Access Compliance Report

Intersection ID: 10033521	Main Street: OLD_PROVIDENCE_RD	Cross Street: N/A	Location: NW
ADA ID: B0E7294DA76F	Ramp Type: PerpDiag	Initial Pass/Fail: Fail	Overall Compliance: No Severity Score: 13.75

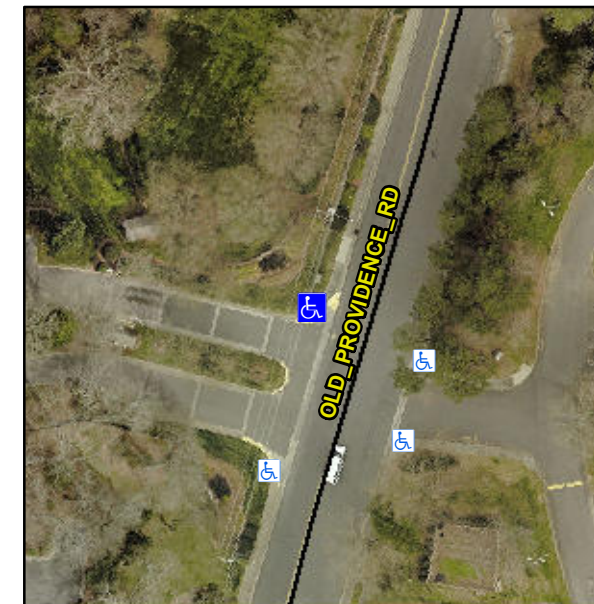
Not Found, R304.2.2, R304.5.3

Compliance	Description	Data	Compliance	Description	Data
N/A	Ramp Length (in)	60.0	No	Ramp Slope (%)	9.3
Yes	Ramp Width (in)	56.0	No	Ramp XSlope (%)	4.9
N/A	Flare Type LT	N/A	N/A	Flare Type RT	N/A
N/A	Flare Slope LT (%)	N/A	N/A	Flare Slope RT (%)	N/A
N/A	Flare Traversable LT?	N/A	N/A	Flare Traversable RT?	N/A
N/A	Landing Length (in)	N/A	N/A	DWS Provided?	N/A
N/A	Landing Width (in)	N/A	N/A	DWS Contrast?	N/A
N/A	Landing Slope (%)	N/A	N/A	DWS Length (in)	N/A
N/A	Landing X Slope (%)	N/A	N/A	DWS Full Width?	N/A
N/A	Landing Curb? (Y/N)	N/A	N/A	DWS Offset (in)	N/A
N/A	Shared Landing?	N/A			
N/A	Gutter Ponding?	N/A	N/A	Gutter Slope (%)	N/A
N/A	Gutter Lip Ht (in)	N/A	N/A	Gutter X Slope (%)	N/A
N/A	Painted X Walk1?	No	N/A	Painted X Walk2?	No
	X Walk 1 Direction	To SW		X Walk 2 Direction	To SE
N/A	X Walk 1 Width (in)	N/A	N/A	X Walk 2 Width (in)	N/A
	X Walk 1 Slope (%)	1.5		X Walk 2 Slope (%)	3.9
	X Walk 1 X Slope (%)	7.1		X Walk 2 X Slope (%)	1.2

Remove & Replace Curb Ramp With Two New Directional Ramps or Equivalent.
